Job No: IAC-333

Reference: Eastern Offices Accessibility Review – Access Report
Development Application

ACCESS REPORT DEVELOPMENT APPLICATION

Project: Sydney Opera House
Eastern Offices
Document Type: Access Report – Development Application
Report Number: IAC-333

5. STAIR GS26

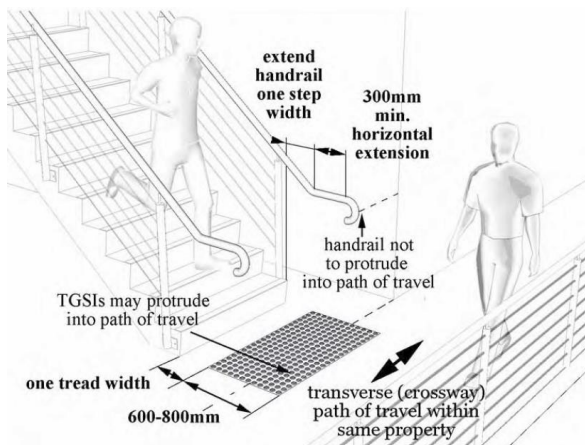
The detailing of this stair will need to be upgraded from a fire Isolated stair as this stair will become a circulation stair connecting these two levels.

The following will need to be provided to the flights connecting the two office levels:

- Handrails installed to both sides of the stair flights
- Provision of compliant handrail extensions
- Non slip goings
- Installation of non-slip nosing to each going
- Installation of warning TGSIs at landings (TGSIs not required at mid-landings)
- Compliant lighting levels

6. STAIR – INTERNAL CIRCULATION STAIR

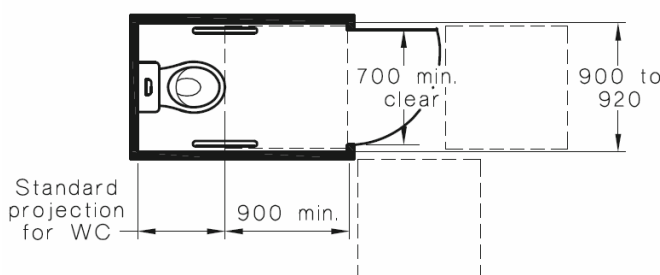
A new stair is proposed to be installed within the Theatre and Events Office.

The position of the stair will need to be adjusted so that the handrail extensions do not encroach on the path of travel.

The detailing of the interconnecting stair will need to demonstrate compliance with Clause 11 and 12 of AS1428.1:2009. Specific attention is directed to:

- Handrails design
- Compliant handrail extensions and handrail terminations
- Non slip going
- Installation of non-slip nosing to each going
- Installation of warning TGSIs at landings (TGSIs not required at mid-landings)
- Compliant lighting levels
- Opaque risers

7. WC FACILITIES

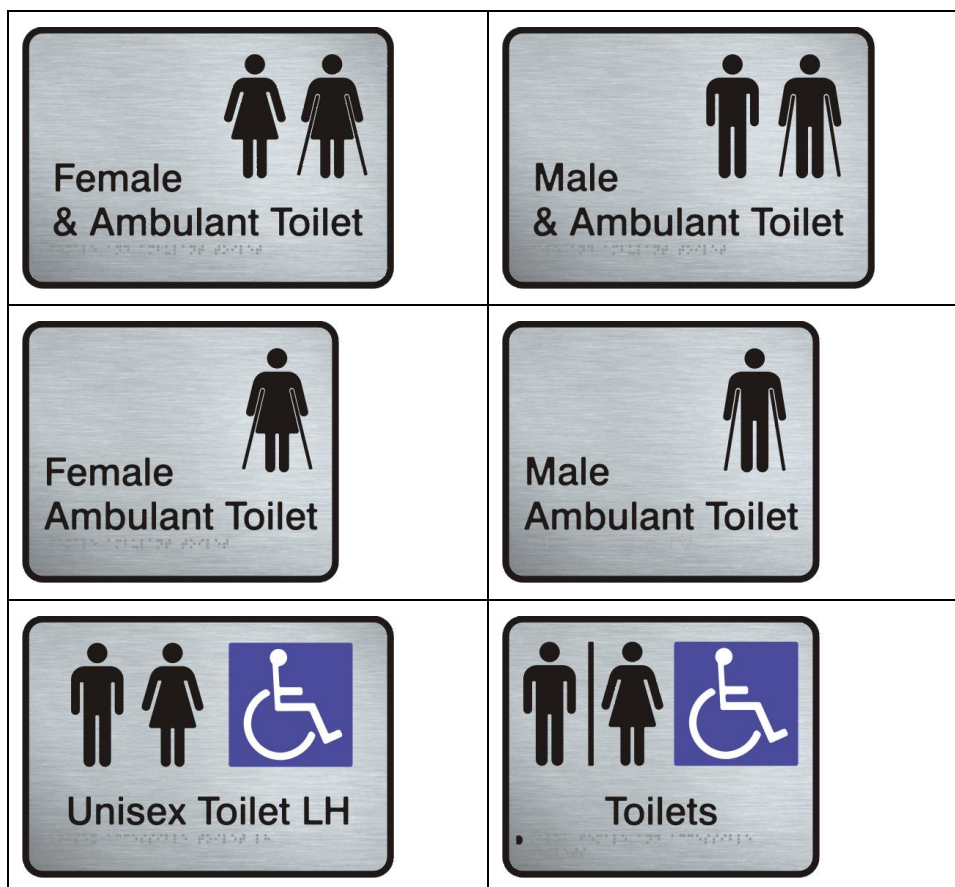
The plans propose ambulant facilities associated with individual male and female WC amenities. The setout of the Ambulant WC will need to satisfy the provisions of Clause 16 of AS1428.1:2009. Braille Tactile signage will need to be installed to the ambulant WC cubicle doors. The detailing and positioning of the Braille Tactile signage will need to satisfy NCC Clause D3.6 and NCC Specification D3.6.

The circulation at the doorway to the male ambulant WC will need to demonstrate compliance with the provisions of Clause 16 of AS1428.1:2009.

The sizing of the GM.404 Amenities Lobby will need to facilitate a 1540 x 2070mm zone to enable 180deg turns for wheelchair users.

8. CIRCULATION – F+B OFFICE

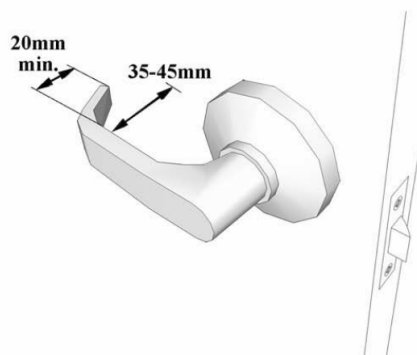
The F+B Office (G.401) may require review.

It will be essential to demonstrate that it is possible for a wheelchair user to make a 180deg turn within this office. The Standard nominates that a zone of 1540 x 2070 is required to undertake this turn.
